REMEDIATION SYSTEM EVALUATION

RISDON CORPORATION  
DANBURY, CONNECTICUT

Report of the Remediation System Evaluation,  
Site Visit Conducted at the Risdon Corporation Site  
January 15, 2003

**Remediation System Evaluation  
Risdon Corporation  
Danbury, Connecticut**

**FIGURE 1-3. EXTENT OF VOC CONTAMINATION BASED ON THE SEPTEMBER 2001 SAMPLING EVENT AND THE 2002 OFF-PROPERTY SOIL VAPOR AND GROUNDWATER SAMPLING REPORT. THE ORIENTATION OF CROSS-SECTION A-A' IN FIGURE 1-2 IS DEPICTED.**

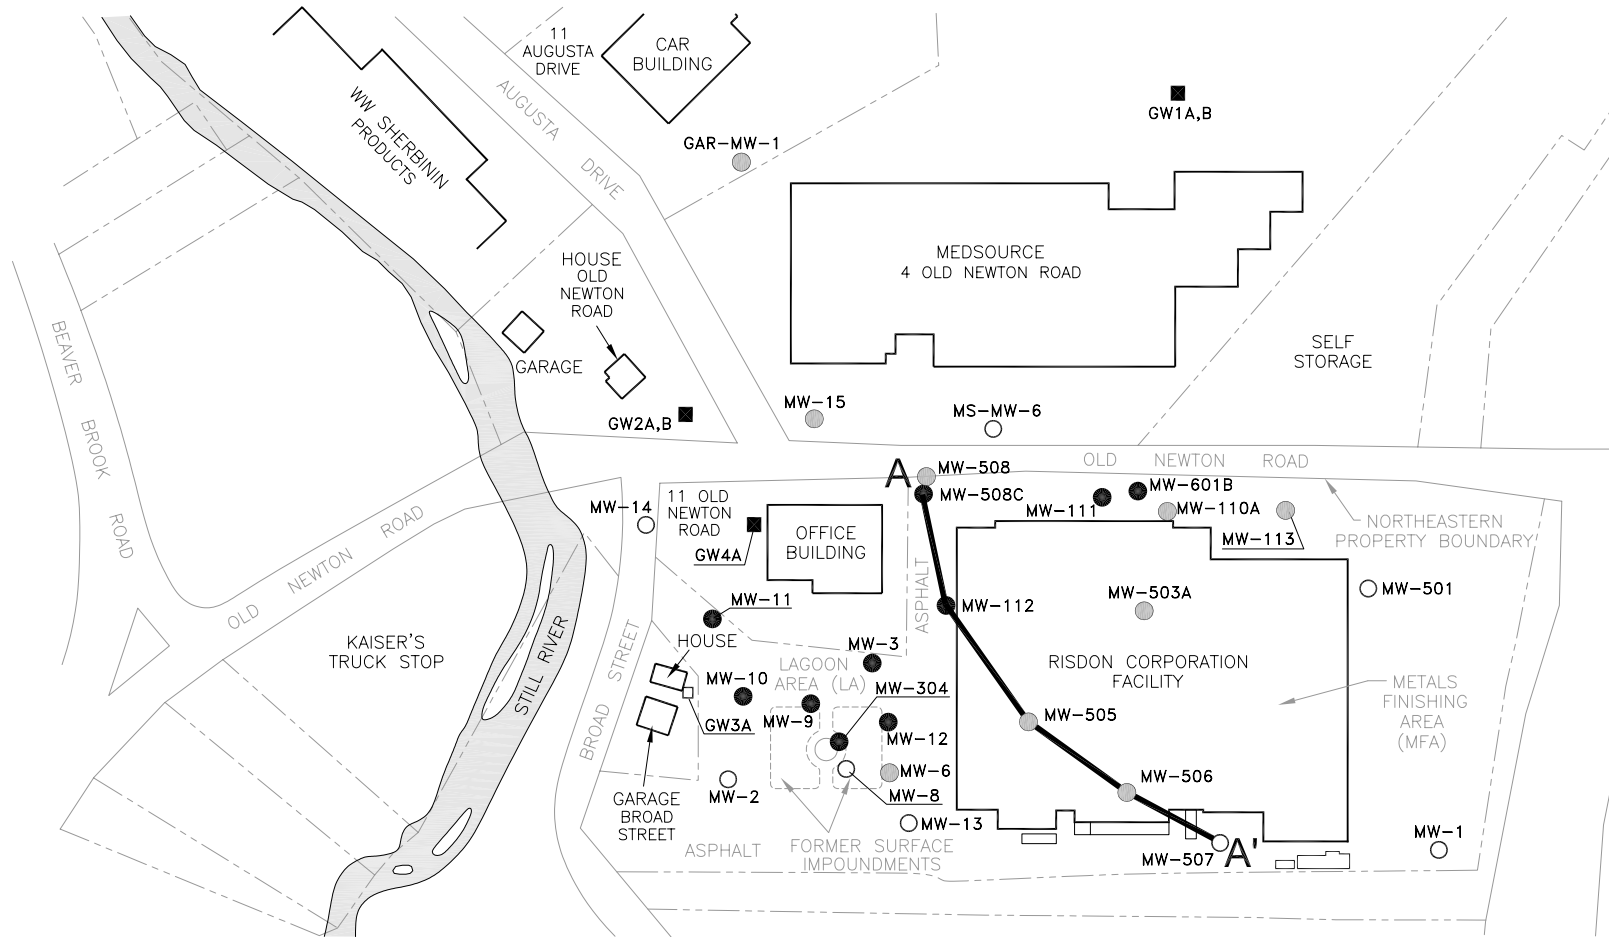
information with regard to the extent of the bedrock contamination found in MW-508C. The majority of the existing offsite monitoring wells are depicted in Figure 1-3.

**FIGURE 4-1. POTENTIOMETRIC SURFACE MAP PROVIDED IN THE JANUARY 2003 GROUNDWATER MONITORING REPORT.**

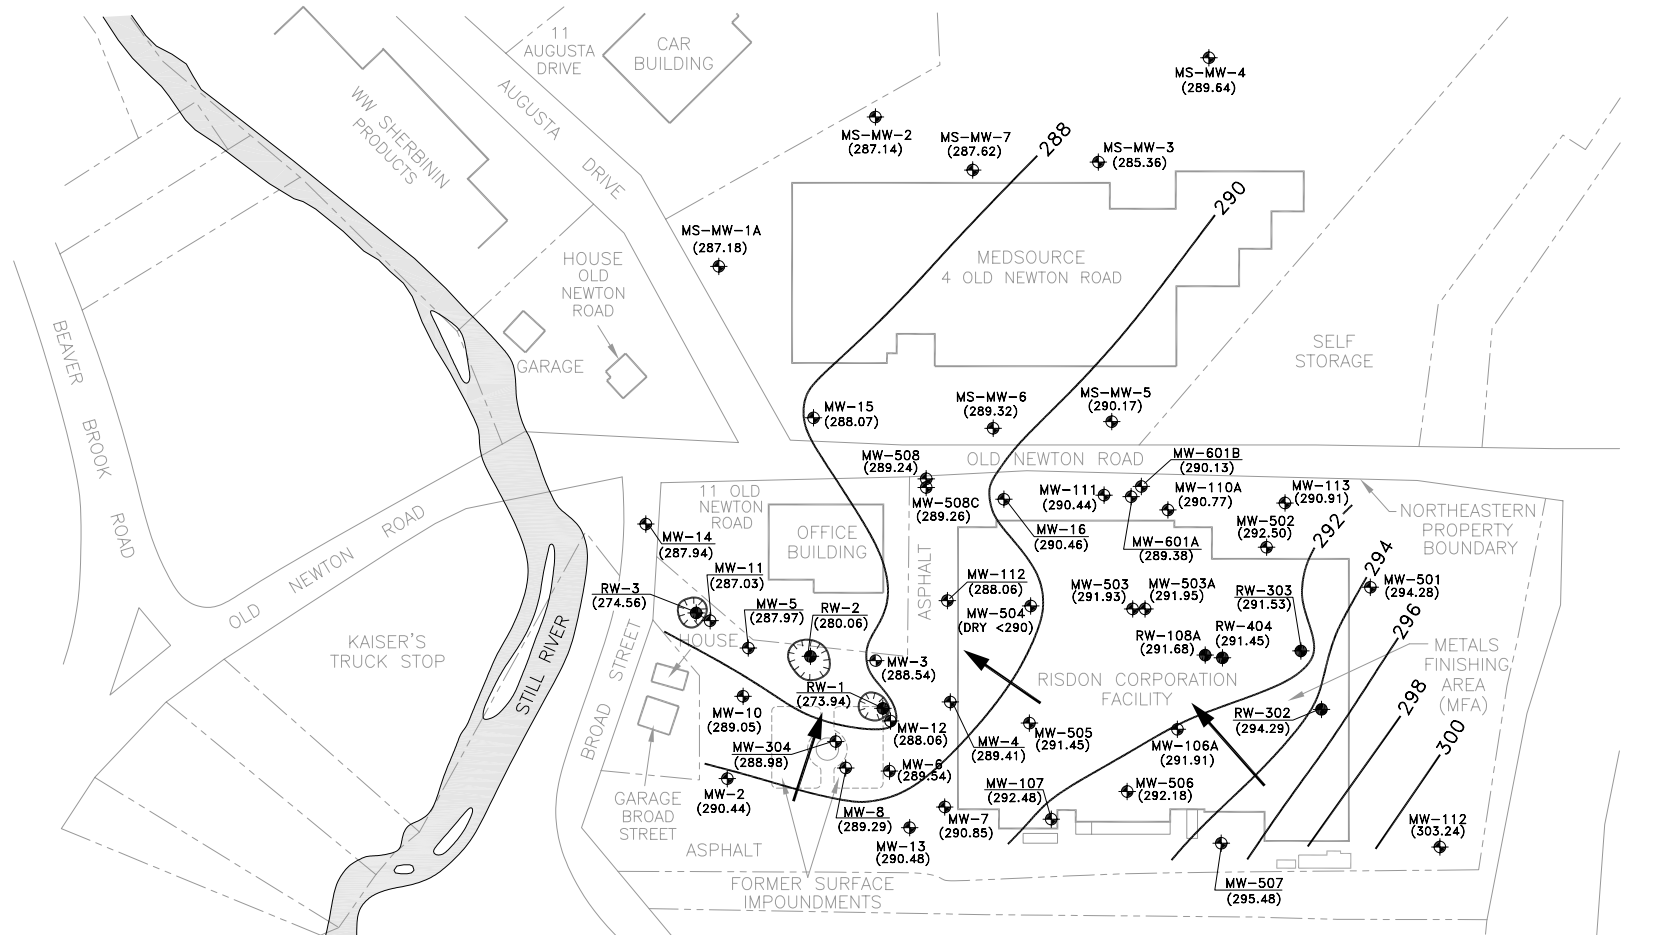
Ground water levels are collected and interpreted with each monitoring event. The potentiometric surface map presented in the January 2003 Ground Water Monitoring Report is included as Figure 4-1. It shows what appears to be influence of both P&T systems on the regional ground water flow. For example, the map shows that the regional gradient flattens in the MFA where extraction is occurring and cones of depression near each of the LA extraction wells. The contours, however, are influenced by the water elevations measured from operating extraction wells. Because extraction wells are subject to well losses and have very localized drawdown due to pumping, water levels from these wells are not necessarily indicative of the water level in the surrounding formation. As a result, if other water level measurements are not made in the area, some of the contours may show excessive influence due to pumping and perhaps an overestimated interpretation of plume capture. Specific examples of where the contours may overestimate the influence of pumping are as follows:

The monitoring report also does not provide the extraction rates for the various wells. Although extraction rates for the LA wells were originally 3 gpm each for a total of 9 gpm, the pumping has likely changed. In 1996, the total extraction rate was estimated at 3.5 gpm, and during the RSE site visit the flow totalizers for these wells revealed a total pumping rate of approximately 4.5 gpm, with RW-3 not operating. To better resolve the influence of pumping on the regional hydraulic gradient, the pumping rates should be provided along with the potentiometric surface maps, when possible.

**FIGURE 6-1. RECOMMENDED LOCATIONS FOR ADDITIONAL EXTRACTION WELLS.**

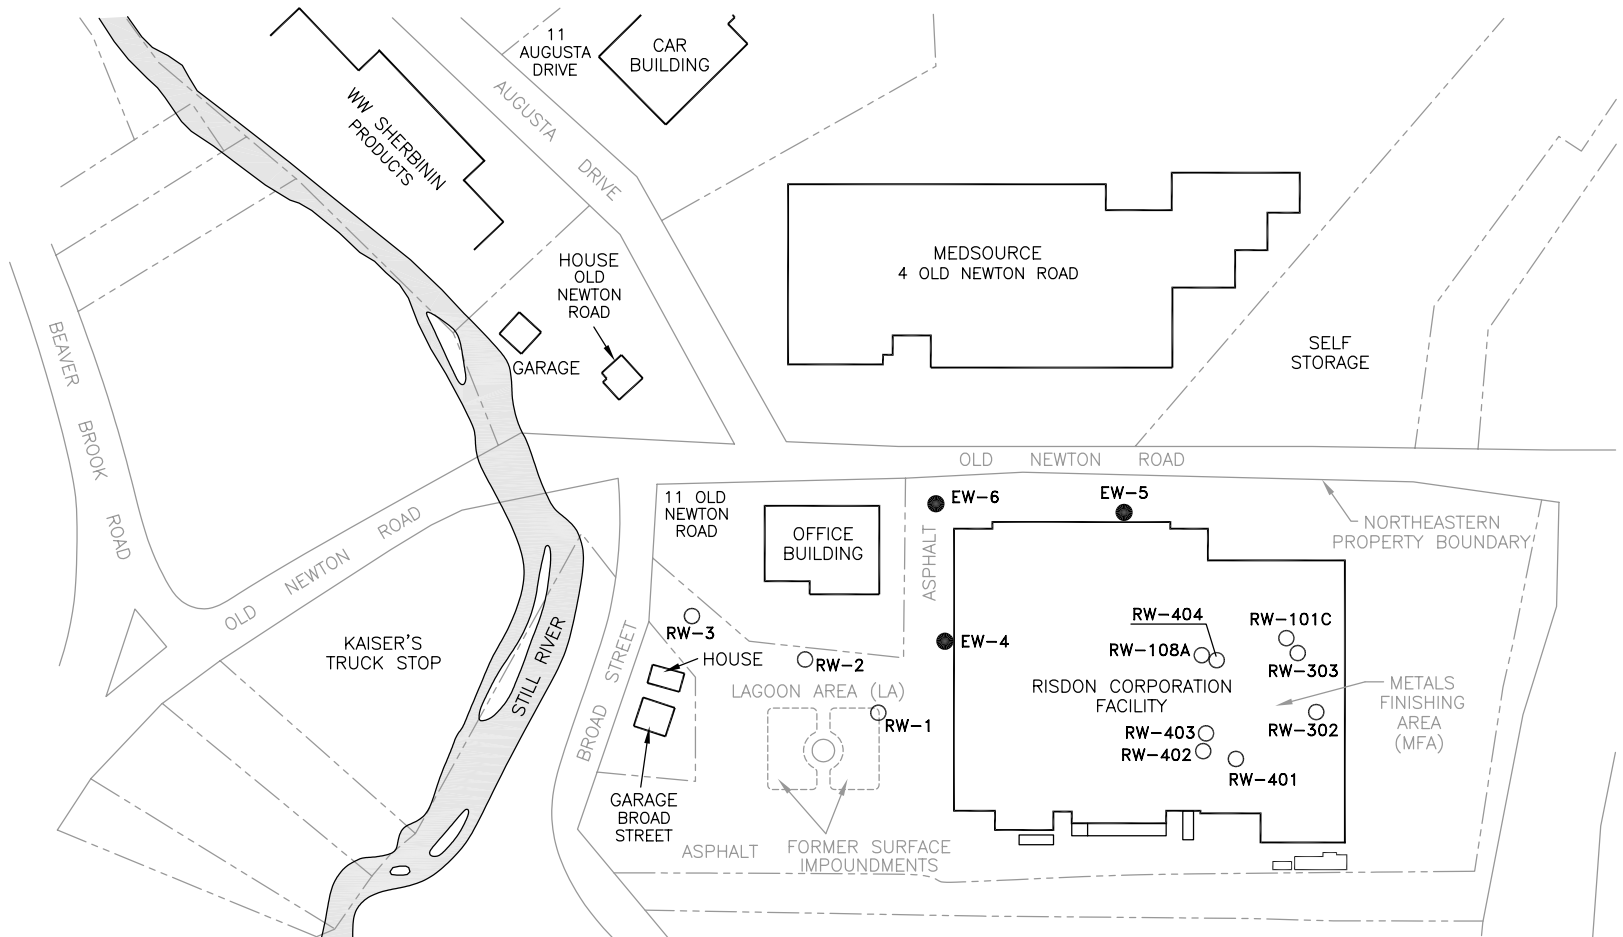
### **6.1.3 ADD EXTRACTION WELLS TO PROVIDE HYDRAULIC CONTAINMENT NEAR THE PROPERTY BOUNDARY**

- It should work in concert with pumping from the LA to prevent offsite migration of contamination in both the overburden and the bedrock (i.e., stabilize the site).
- It should provide a zone of capture that, if possible, does not include receptors. That is, the extraction wells should be located such that contamination is not pulled near potential receptors at levels that pose an unacceptable risk.

Submersible pumps should be used at the new wells because they allow for drawdown beyond ~27 feet (~80% of a perfect vacuum), which is the maximum the aboveground pumps can draw. The extra drawdown may or may not be necessary but in case it is, submersible pumps can provide it for a cost similar to aboveground pumps. The facility might also potentially save cost on smaller vault construction by using submersible pumps.
